Call for the more precise implementation of
statutory orders regarding existing weight
limits in Highgate and Dartmouth Park

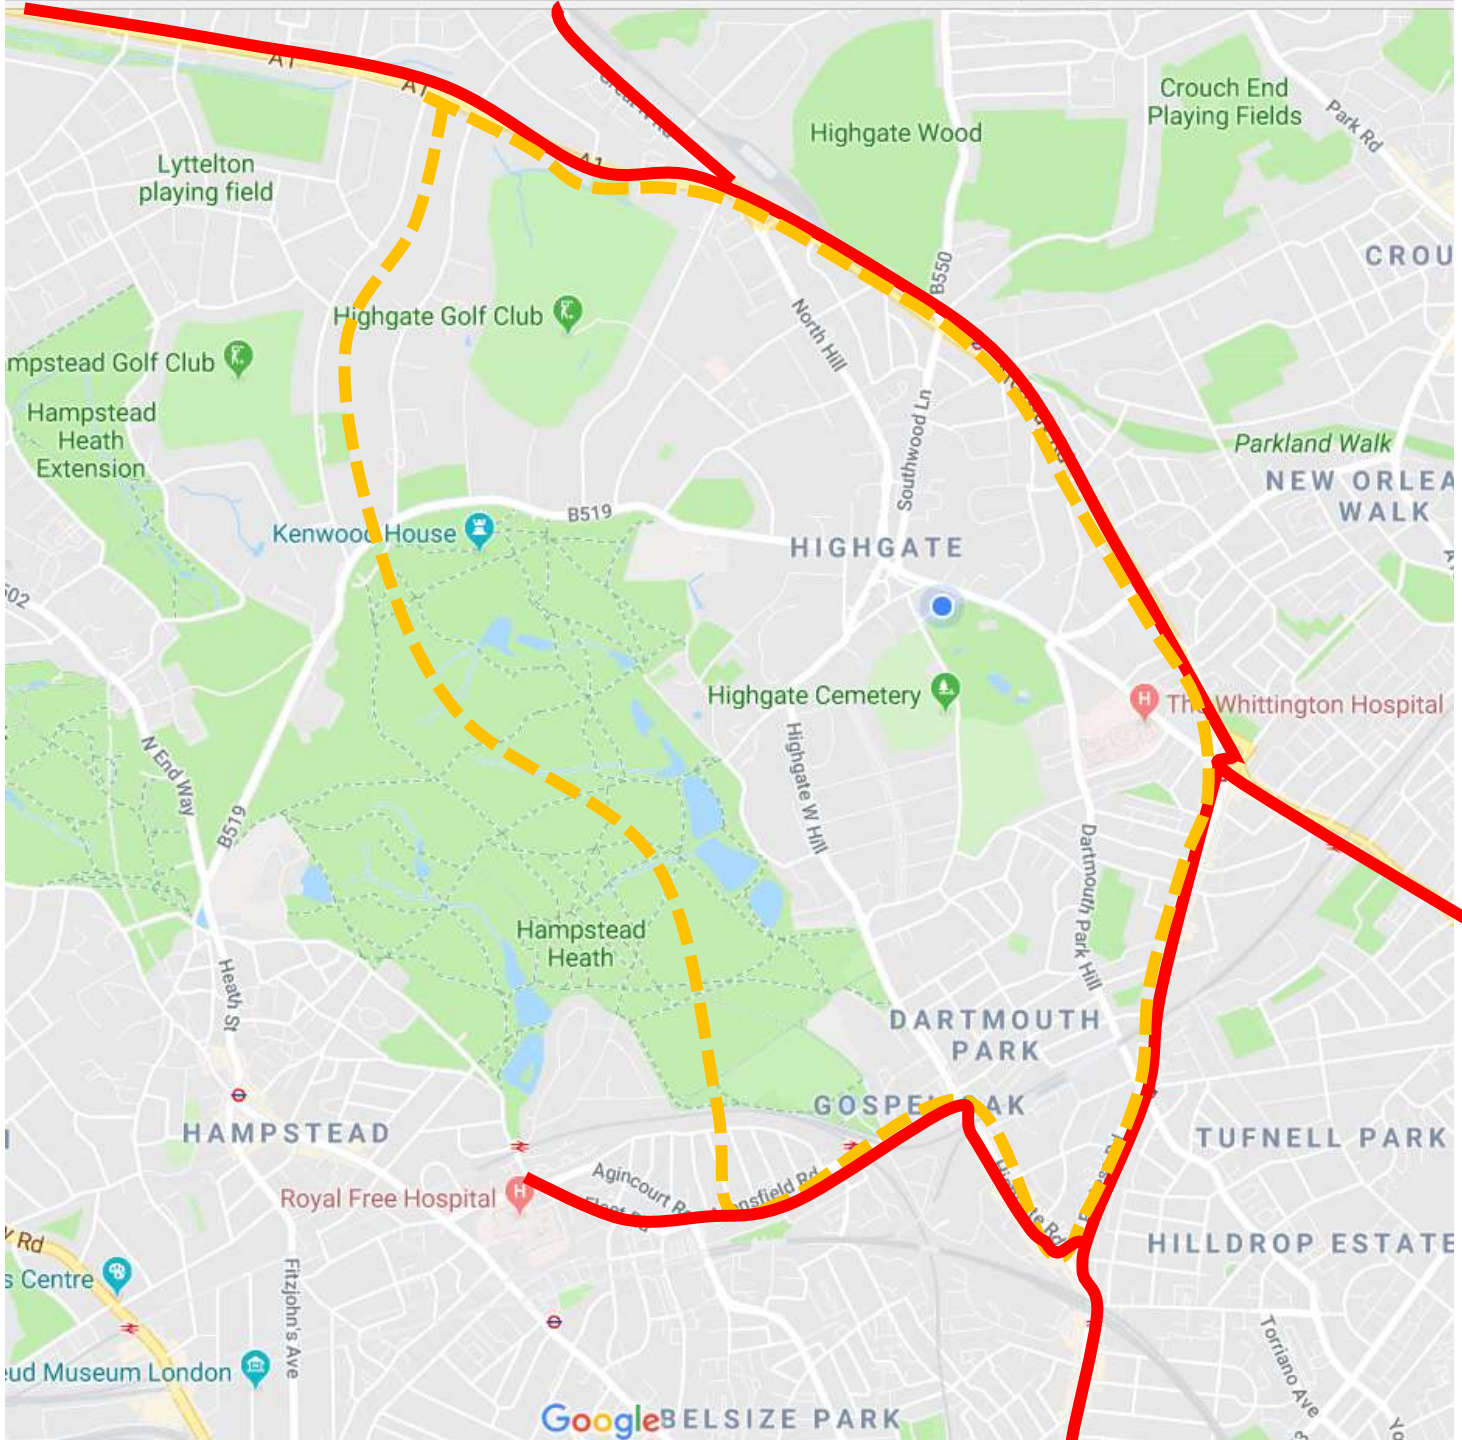
Disregarding that part of N6 lying east of the Archway Road, one can identify a cordon which heavy vehicles should not cross other than for access. This cordon is shown in orange
